# UNITED STATES PATENT AND TRADEMARK OFFICE

APPLICATION NO.	FILING DATE	FIRST NAMED INVENTOR	ATTORNEY DOCKET NO.	CONFIRMATION NO.
10/825,103	04/16/2004	Hitoshi Saito	SON-3000	7692
23353 7590 01/23/2008 RADER FISHMAN & GRAUER PLLC LION BUILDING 1233 20TH STREET N.W., SUITE 501 WASHINGTON, DC 20036			EXAMINER RENNER, CRAIG A	
			ART UNIT 2627	PAPER NUMBER
			MAIL DATE 01/23/2008	DELIVERY MODE PAPER

<b>Office Action Summary</b>	Application No. 10/825,103	Applicant(s) SAITO ET AL.	
	Examiner Craig A. Renner	Art Unit 2627

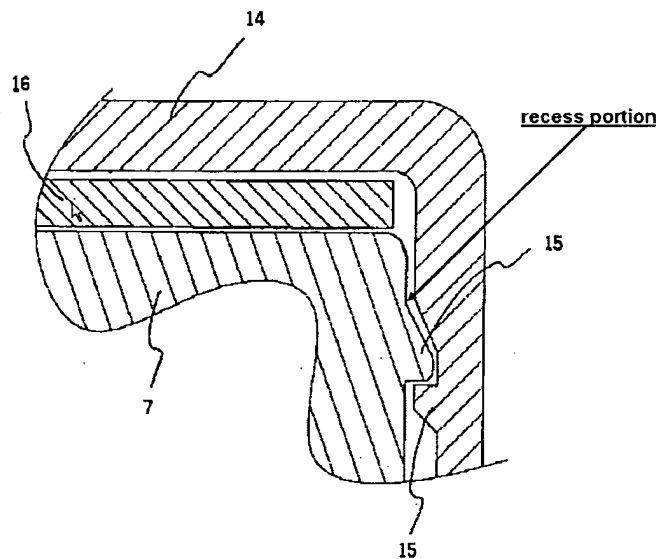
Fujihata et al. (JP 2001-125667) teaches a disk drive apparatus comprising a disk drive body (includes 7) including a front face having an insertion opening (12) for a disk (i.e., such as a hard disk PCMCIA card) and faces substantially parallel to a recording surface of an inserted disk; and a decorative panel (14) covering approximately the entire surface of the faces and being disposed so as to be detachable from the side faces (as shown in FIGS. 2 and 3, for instance) [as per claim 1]; wherein the decorative panel comprises a flat panel portion (14) shaped as a rectangle by having a periphery thereof with longer-sides and shorter-sides (as shown in FIG. 4, for instance); shorter-side members disposed along the shorter-sides of the flat panel portion (as shown in FIG. 3, for instance); and at least one shorter-side engagement member (15) comprising one of a first engaging piece and a first engaging groove (i.e.,

in this case, a first engaging piece) provided at the shorter-side members for engagement with the disk drive body (as shown in FIGS. 2 and 3, for instance) [as per claim 2]; wherein the disk drive body is disposed in the vicinity of the one of the first engaging piece and the first engaging groove in a state in which the decorative panel is installed on the disk drive body (as shown in FIGS. 2 and 3, for instance), and the disk drive body has a recess portion (as shown below, for instance) disposed so as to oppose to the shorter-side member;

and wherein the decorative panel comprises a flat panel portion (14) shaped as a rectangle by having a periphery thereof with longer-sides and shorter-sides (as shown in FIG. 4, for instance); shorter-side members disposed along the shorter-sides of the flat panel portion (as shown in FIG. 3, for instance); and at least one shorter-side engagement member (15) comprising one of a first engaging piece and a first engaging groove (i.e., in this case, a first engaging piece) provided at the shorter side members

mechanically interlocked with the disk drive body (as shown in FIGS. 2 and 3, for instance) [as per claim 8].
